Colorado Springs, CO

Final Report - Corrections Required **Application No. ANEX-24-0006**

Description : Matrix Design Group on behalf of Colorado Springs Equities LLC is submitting a serial annexation petition for seven parcels and Land Use Plan/Rezoning exhibit for a portion of the subdivision known as Rock Creek Mesa.

ANNEXATION PLAT ROCK CREEK MESA ADDITION NO. 6

CHECKED BY: JRB SCALE: NA DATE ISSUED: JANUARY 3, 2024
SHEET 1 OF 2

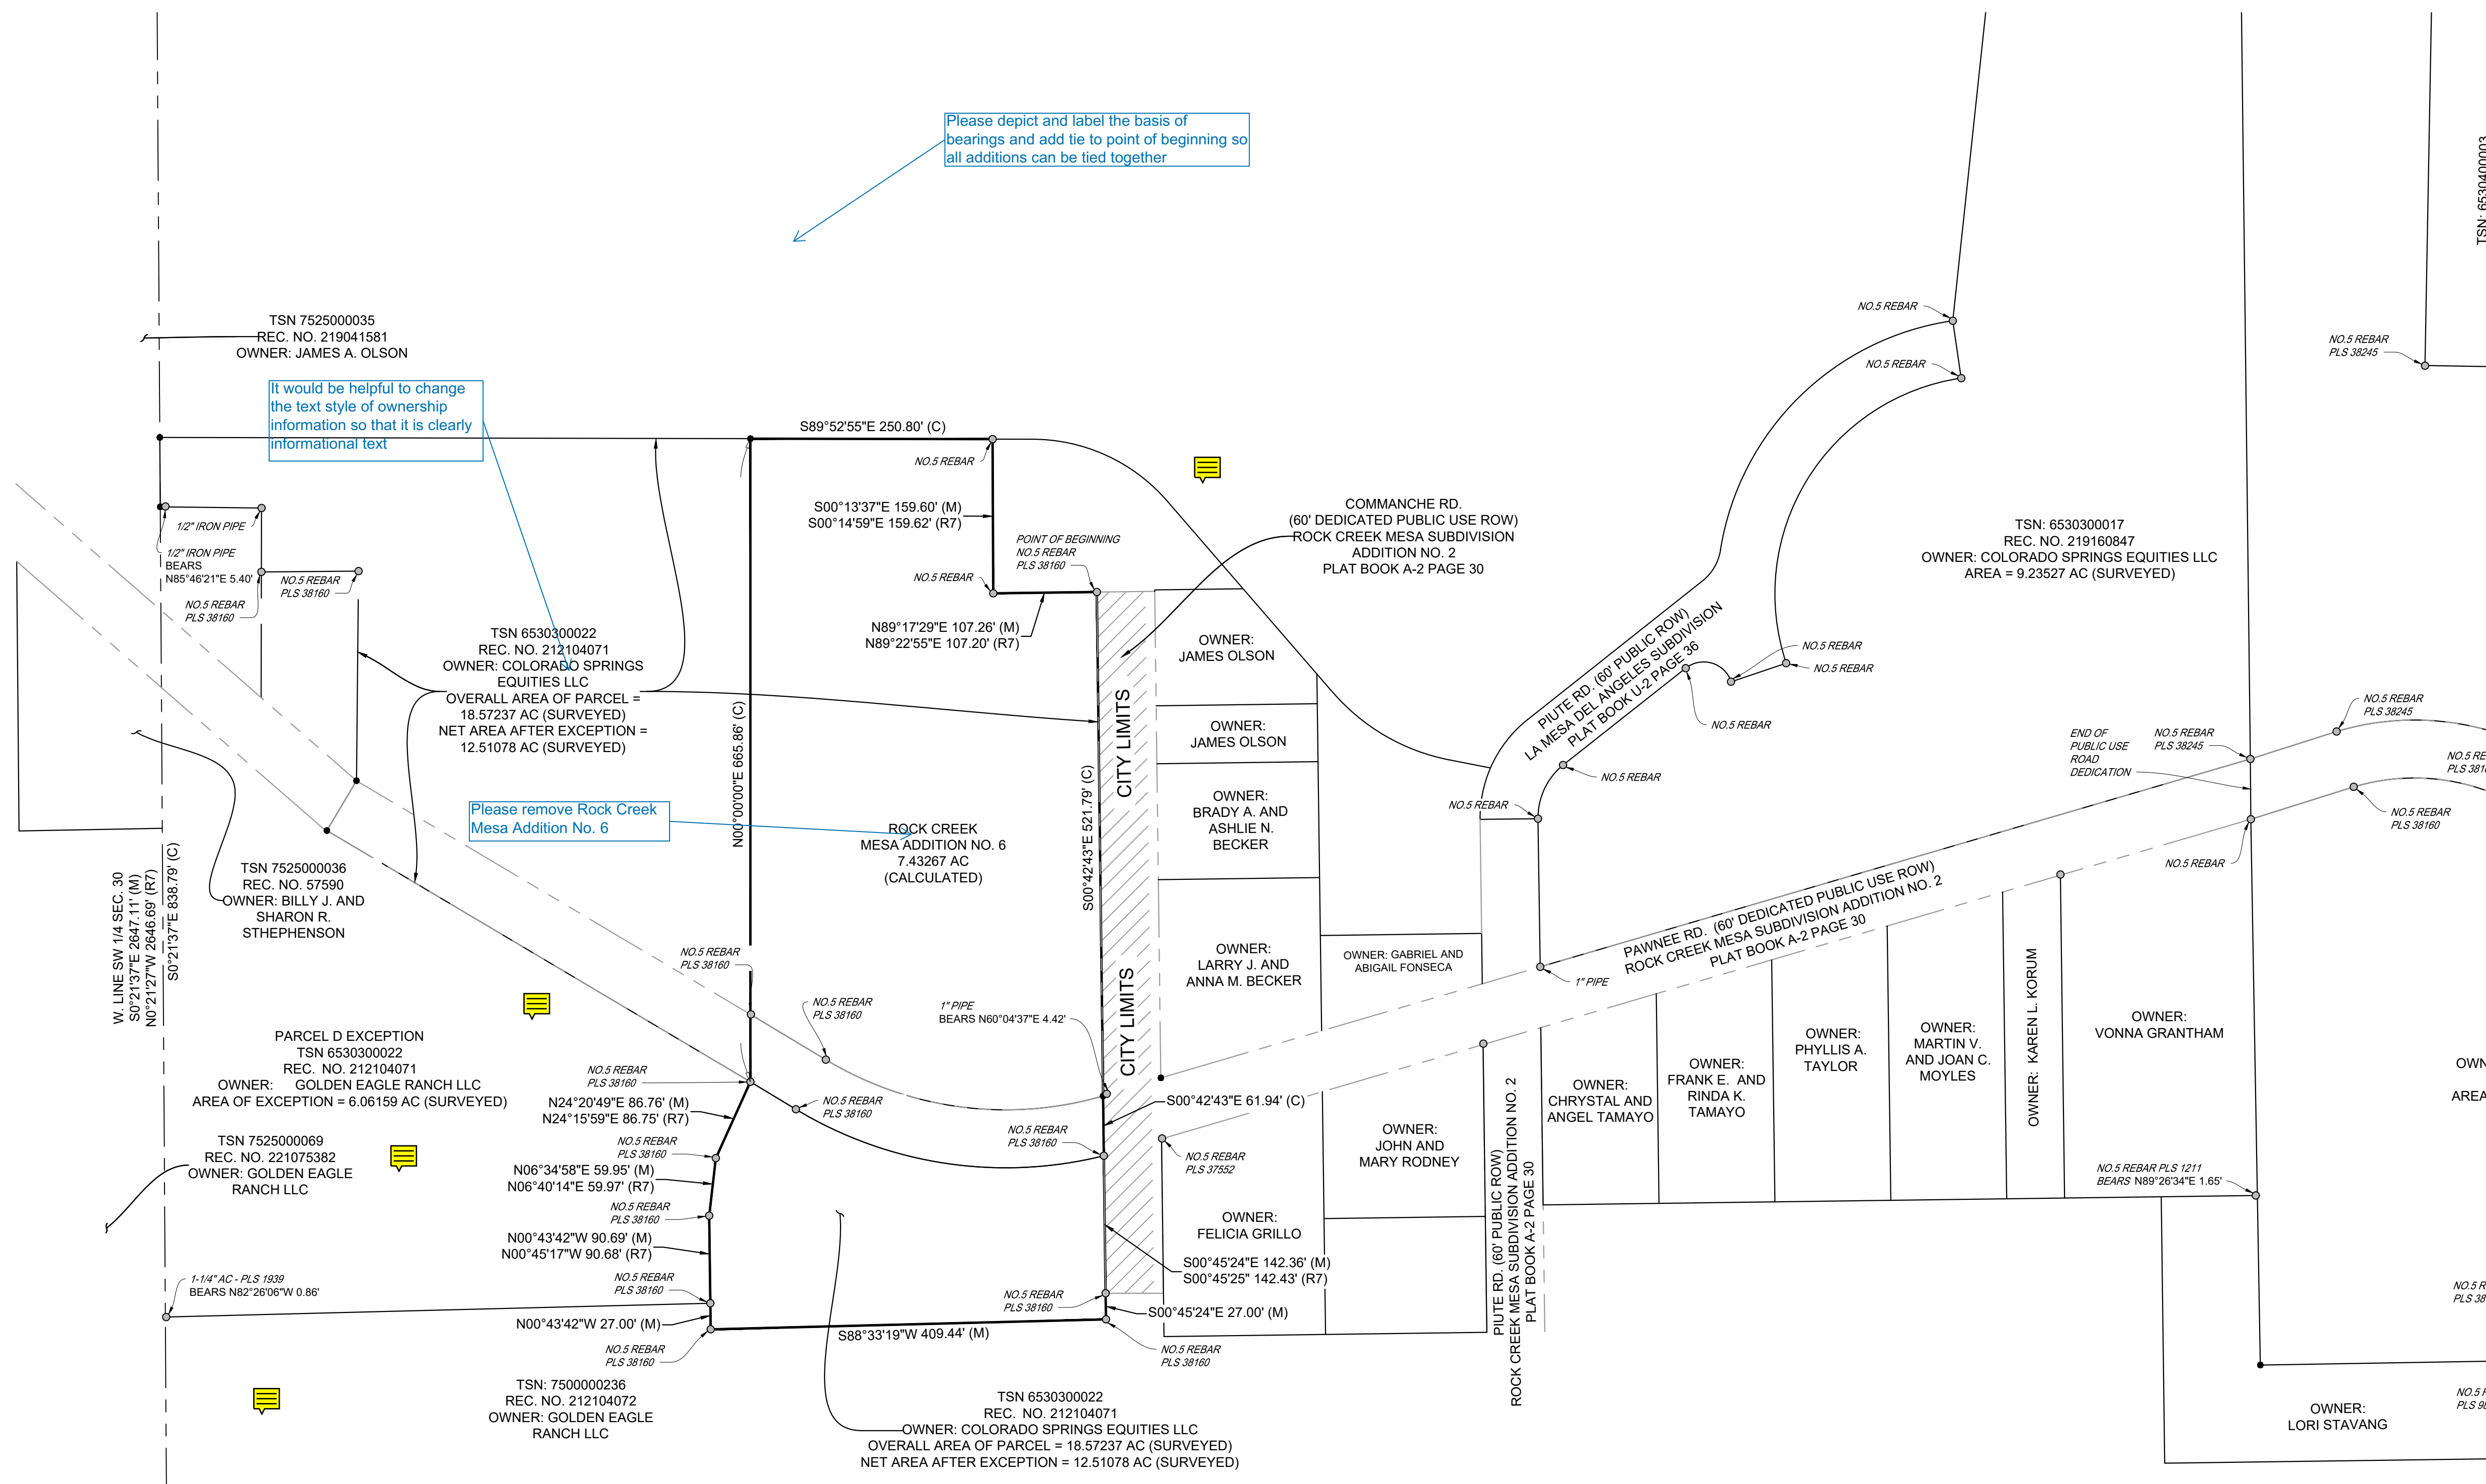
14	224.023-SURV-RCM ANNEX PLAT 6-TITLE	Sara Rivera : City Engineering - SWENT	The FEMA floodplain zone is incorrect. Please update to the correct zone.
2	224.023-SURV-RCM ANNEX PLAT 6-TITLE	Matthew Alcuran : Col Springs Utilities	<p>Please acknowledge the following Water Planning Informational Note: Please refer to the completed Hydraulic Analysis Report completed on November 2, 2023 for HR Green and SSS Education. Conclusions and Requirements: **Modeled fire flows are 2100 to 2200 GPM. No fire flow requirement was provided. **Either alternative presented in this report are acceptable. **Since all pressures are below 170 psi, PVC is acceptable.</p>
3		Matthew Alcuran : Col Springs	Utility Comments (electric, gas, water, wastewater)

Comment ID	Page Reference	Reviewer : Department	Review Comments
8	224.023-SURV-RCM ANNEX PLAT 6-TITLE	Matthew Alcuran : Col Springs Utilities	Please respond to CSU LBS comments: Have reviewed and entered geometry into FIMS. "Please add detail to the Point of Beginning, such as 'the most northerly corner on the most easterly line of said parcel'." "The first course references 'said Commanche Rd' when not referenced earlier."
15	224.023-SURV-RCM ANNEX PLAT 6-TITLE	Gabe Sevigny : Planning	Update ANEX-24-0006 on each sheet
19	224.023-SURV-RCM ANNEX PLAT 6-TITLE	Cory Sharp : Planning	Please update 3, 4 & 5 to the following contiguity statement: contiguity statement: Total Perimeter of the Area for Annexation: 2,610.45' One-Fourth (1/4th) of the Total Perimeter: 652.61' (25.00%) Perimeter of the Area Contiguous to the Existing City Limits: 726.09' (27.81%)
22	224.023-SURV-RCM ANNEX PLAT 6-TITLE	Cory Sharp : Planning	Please add quotations around the plat name "Rock Creek Mesa Addition No. 6"

23	224.023-SURV-RCM ANNEX PLAT 6-TITLE	Cory Sharp : Planning	Please add the area at the end of the legal description
24	224.023-SURV-RCM ANNEX PLAT 6-GRAPHIC 1	Cory Sharp : Planning	Please depict and label the basis of bearings and add tie to point of beginning so all additions can be tied together
25	224.023-SURV-RCM ANNEX PLAT 6-GRAPHIC 1	Cory Sharp : Planning	Please remove Rock Creek Mesa Addition No. 6
26	224.023-SURV-RCM ANNEX PLAT 6-GRAPHIC 1	Cory Sharp : Planning	It would be helpful to change the text style of ownership information so that it is clearly informational text
27	224.023-SURV-RCM ANNEX PLAT 6-GRAPHIC 1	Cory Sharp : Planning	Please add (M) and (C) to the legend
28	224.023-SURV-RCM ANNEX PLAT 6-GRAPHIC 1	Cory Sharp : Planning	Please remove the areas from all adjacent parcels
29	224.023-SURV-RCM ANNEX PLAT 6-GRAPHIC 1	Cory Sharp : Planning	Please clearly depict all of the city limits not just that adjacent portion

Please acknowledge the following Water Planning Informational Note:
Please refer to the completed Hydraulic Analysis Report completed on November 2, 2023 for HR Green and SSS Education. Conclusions and Requirements:
**Modeled fire flows are 2100 to 2200 GPM. No fire flow requirement was provided.
**Either alternative presented in this report are acceptable.
**Since all pressures are below 170 psi, PVC is acceptable.

Please add quotations around the plat name 'Rock Creek Mesa Addition No. 6'

- Removal of the recommendation of approval by the Utilities Board
- Removal of the 25% contiguity requirement. Please add the area at the end of the legal description.

Please respond to CSU LBS comments:
Have reviewed and entered geometry into FIMS.

"Please add detail to the Point of Beginning, such as 'the most northerly corner on the most easterly line of said parcel!'"

"The first course references 'said Commanche Rd' when not referenced earlier."

Update ANEX-24-0006 on each sheet

PREPARED BY: Excellence by Design	ROCK CREEK MESA ADDITION NO. 6 LOCATED IN SECTION 30, TOWNSHIP 15 SOUTH, RANGE 66 WEST OF THE 6TH P.M., COUNTY OF EL PASO, STATE OF COLORADO.		
	CHECKED BY: JRB	SCALE: 1"=100'	DATE ISSUED: JANUARY 3, 2024
		SHEET	2 OF 2

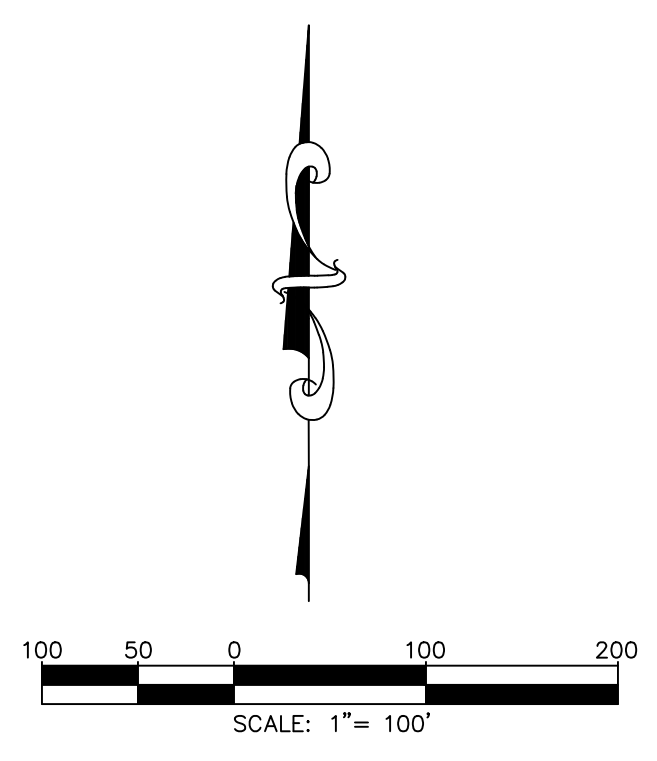
30	224.023-SURV-RCM ANNEX PLAT 6-GRAPHIC 1	Cory Sharp : Planning	Please clearly label the adjacent areas *not a part* for clarity

Comment ID	Page Reference	Reviewer : Department	Review Comments
31	224.023-SURV-RCM ANNEX PLAT 6-GRAPHIC 1	Cory Sharp : Planning	It would be easier for review if the adjacent areas were a dashed line type please review and adjust accordingly

Please depict and label the basis of bearings and add tie to point of beginning so all additions can be tied together

It would be helpful to change the text style of ownership information so that it is clearly informational text

Please remove Rock Creek Mesa Addition No. 6

Please add (M) and (C) to the legend
